IMPORTANT SAFETY RECALL CAMPAIGN ANNOUNCEMENT
NHTSA Recall Campaign # 05V-008

Jayco, Inc. has decided that a defect, which relates to motor vehicle safety, exists in specific model year 2005 Jayco Granite Ridge, Greyhawk, and Escapade Motor Homes.

Subject:	Battery wire routed incorrectly.	
Units Affected:	2005 Class C Motorhomes manufactured between September 2004 through December 2004 • Ambient: M10065-M10091, M20056, M30056, M40051, M50056-M50065 • Greyhawk: MA0061-MA0170, MB0064-MB0124, ME0073-ME0108, MJ0119-MJ0274, MP0067-MP0080, MV0077-MV0122, MY0073-MY0109 • Granite Ridge: RB0061-RB0100, RJ0117-RJ0240 • Escapade: UA0069-UA0074, UG0070-UG0090, UM0053-UM0057, UU0052-UU0057	
Action Required:	Inspection, re-route, replace battery cable line.	
Job Operation Code:	9901057 Ⓝ NOTE: Please provide complete repair description when filing claim.	
Series Code:	Inspect & Repair	RC024
	Inspect & Re-route	RC025
	Inspect, Repair & Re-route	RC026
Flat Rate Time:	Inspect & Repair	0.75 hrs.
	Inspect & Re-route	1.5 hrs.
	Inspect, Repair & Re-route	ST*
	(*) ST time requires prior authorization and pictures before repairs are made.

Fig. 1

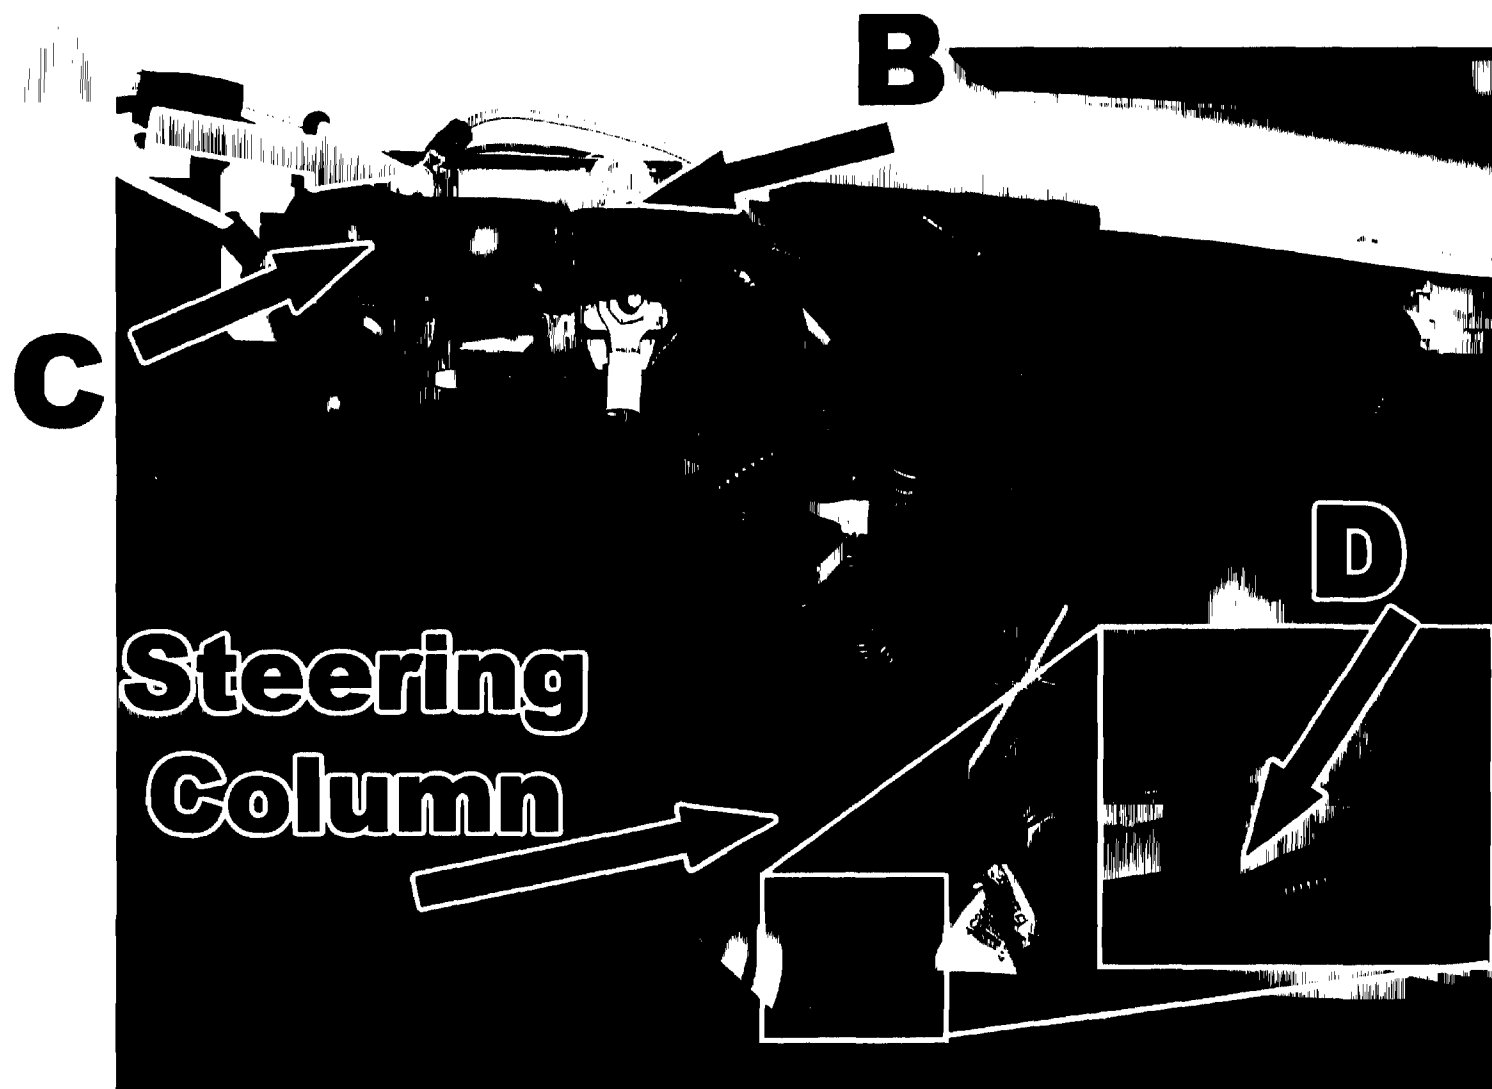
Jayco has become aware that the battery cable may have been routed too close to the exhaust manifold which may result in the cable melting and creating an electrical short and/or fire.

1. Locate the emergency start solenoid (solenoid) and the 30-amp auto reset breaker (breaker) mounted to the firewall in the engine compartment.
2. Locate the orange wire connected to the solenoid (Fig.1A) and the red wire connected to the breaker (Fig. 1B), and the top black battery cable (Fig. 1C). These wires are routed together in a wire harness.

5. The wire harness must route from the solenoid to the driver's side of the steering column (Fig. 1D). From the driver's side of the steering column it must route between the top of the frame rail and the driver's floorboard.

6. Route the wire harness to the driver's side of the steering column (Fig. 1D) and cable tie it to the Ford wire harness. Continue routing the wire harness to the solenoid.

7. Remove the tape from the:
 - orange wire and connect it to the breaker (Fig. 1A).
 - red wire and connect it to the solenoid (Fig. 1B).
 - black battery cable and connect it to the solenoid (Fig. 1C).

8. Route the wire harness to the driver's side of the steering column (Fig. 1D) and cable tie it to the Ford wire harness. Continue routing the wire harness to the solenoid.

5. Route the harness to the driver's side of the steering column (Fig. 1D) and cable tie it to the Ford wire harness. Continue routing the harness to the solenoid.

7. Strip an estimated ¼" of insulation off of the orange and/or red wire(s). Install ring terminals (supplied in the parts kit) to the red and orange wire(s). Connect the orange wire to the solenoid (Fig. 1A). Connect the red wire to the breaker (Fig. 1B).

10. Mount the ring terminal to the solenoid (Fig. 1C).
11. Tighten all connections.
12. Slide the rubber boot over the solenoid terminal to protect the terminal.
